ADDENDUM #1
KEARNEY REGIONAL AIRPORT
NEW HANGAR
KEARNEY, NEBRASKA
1238

Wilkins Hinrichs Stober Architects, L.L.C.
2908 West 39th Street, Suite A
Kearney, Nebraska 68845
308-237-5787

Date Issued: March 13, 2013

1
A1 **CODE PLAN - GROUND FLOOR**
SCALE: 1/8" = 1'-0"

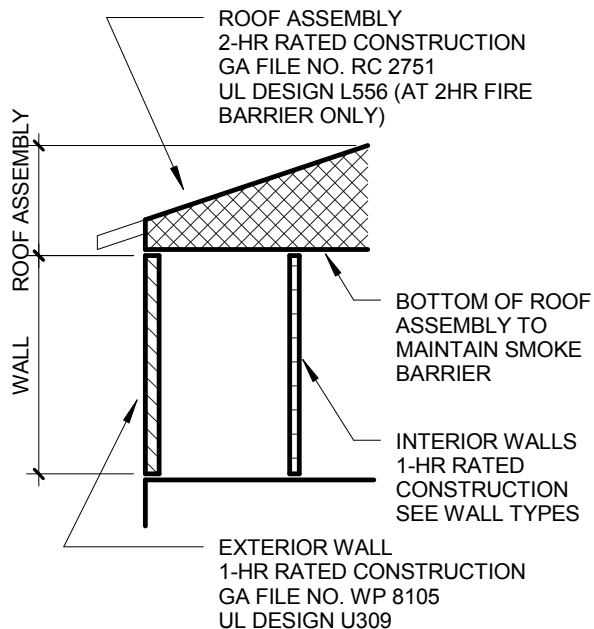
- Addendum #1 - #6 SHEET AC1.0 – CODE PLAN**
1/AC1.0 CODE PLAN – GROUND FLOOR: Revise Occupant Function, Area per Occupant, and Occupant Load of Hangar, Room No. 6, from "Storage/ 100 gross/ 23 Occupants" change to "Aircraft Hangar/ 500 gross/ 44 Occupants".

- Addendum #1 - #7 SHEET AC1.0 – CODE PLAN**
1/AC1.0 CODE PLAN – GROUND FLOOR: Change Door Egress Tags at North-East and South-East of doors of Hangar from "12/170" at each door to "22/170" each door.

- Addendum #1 - #8 SHEET AC1.0 – CODE PLAN**
1/AC1.0 – CODE PLAN – GROUND FLOOR: Revise 2 hr. Fire Barriers and add new note as shown on attachment A1 to Addendum No. 1 dated March 13, 2013

- Addendum #1 - #9 SHEET AC1.0 – CODE PLAN**
Add Detail 2/A1 – CODE PLAN DESIGN SECTION as shown on Attachment A1 to Addendum No. 1 dated March 13, 2013.

DOOR TRACK DRAIN DETAIL

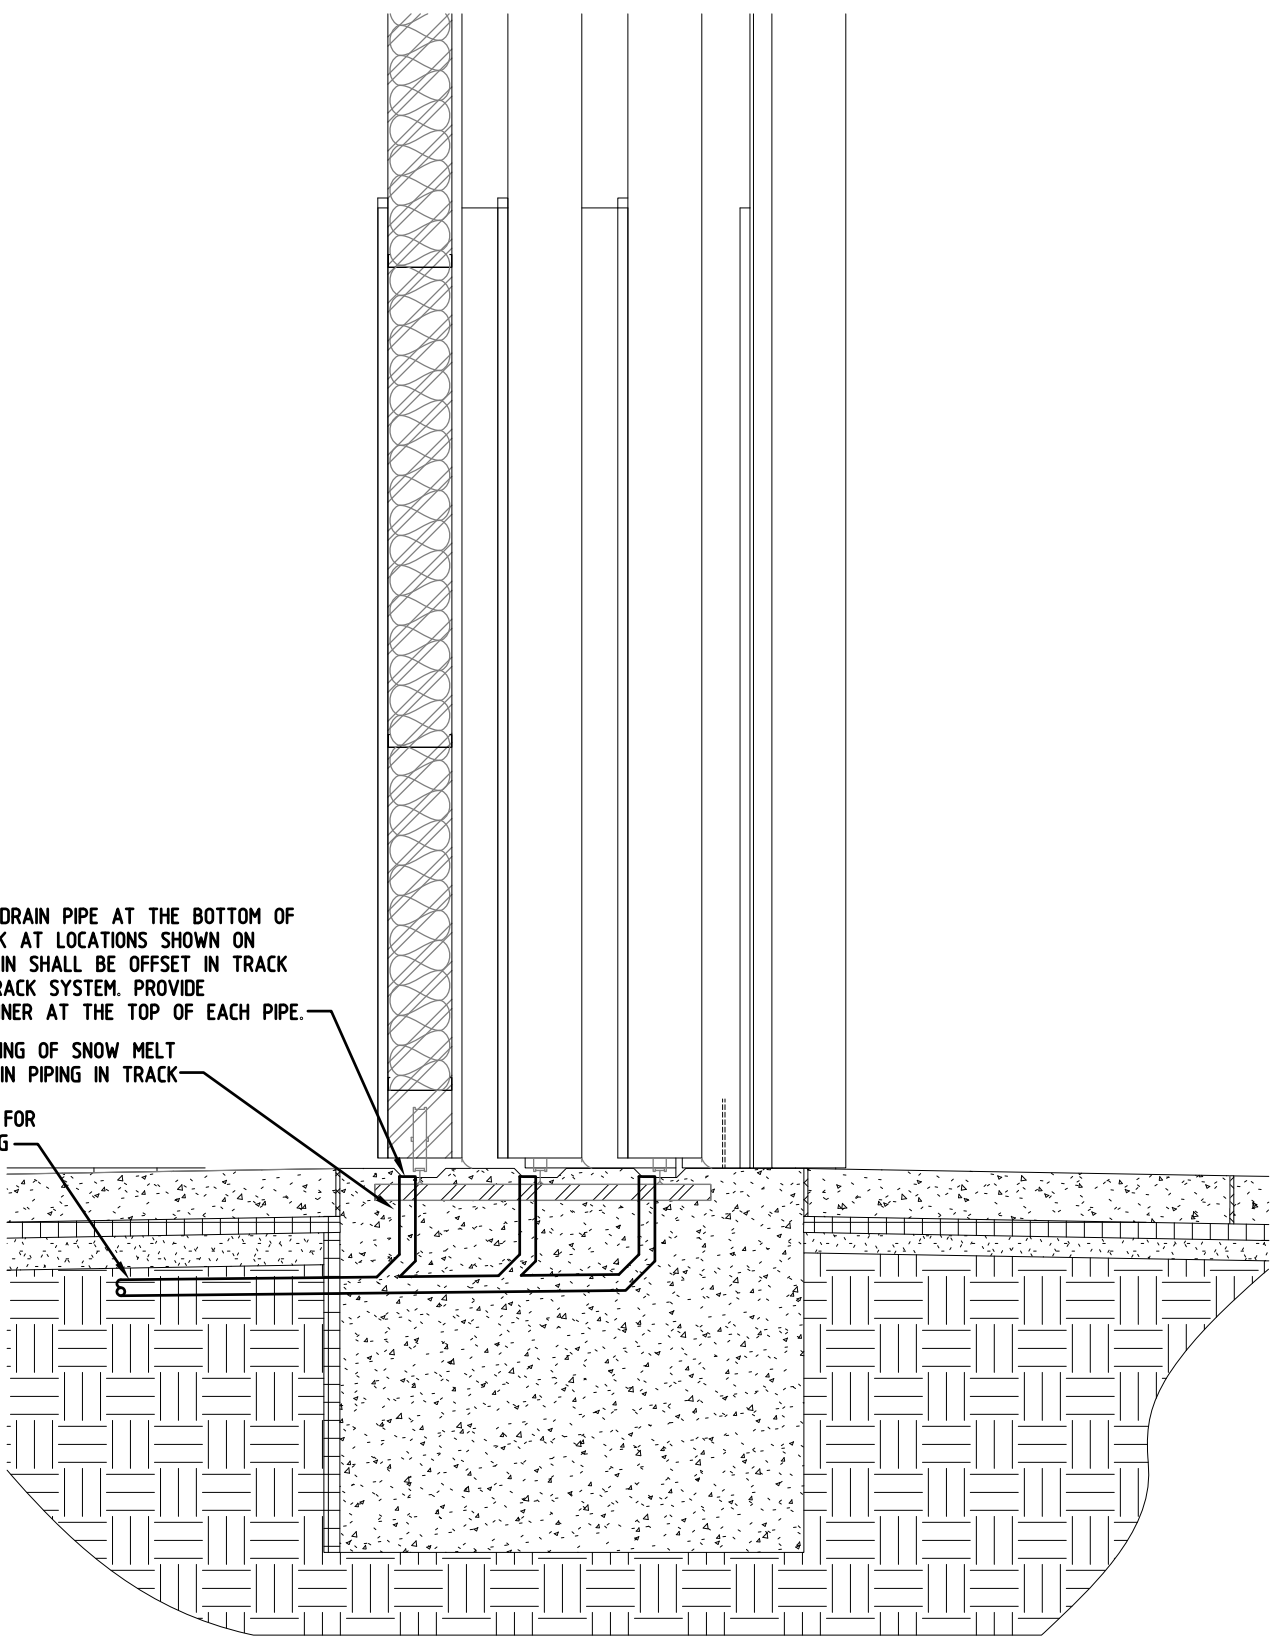
- Addendum #1 - #11 SHEET M1.1 – FIRST FLOOR PLAN – MECHANICAL/HVAC**
Contractor to install a 2” PVC drain pipe in the bottom of each door track at locations shown on the revised plan. See 8.5” x 11” supplemental drawing for cross section detail.

PROVIDE 2" PVC DRAIN PIPE AT THE BOTTOM OF EACH DOOR TRACK AT LOCATIONS SHOWN ON FLOOR PLAN. DRAIN SHALL BE OFFSET IN TRACK TO MISS DOOR TRACK SYSTEM. PROVIDE REMOVABLE STRAINER AT THE TOP OF EACH PIPE.

COORDINATE ROUTING OF SNOW MELT TUBING WITH DRAIN PIPING IN TRACK
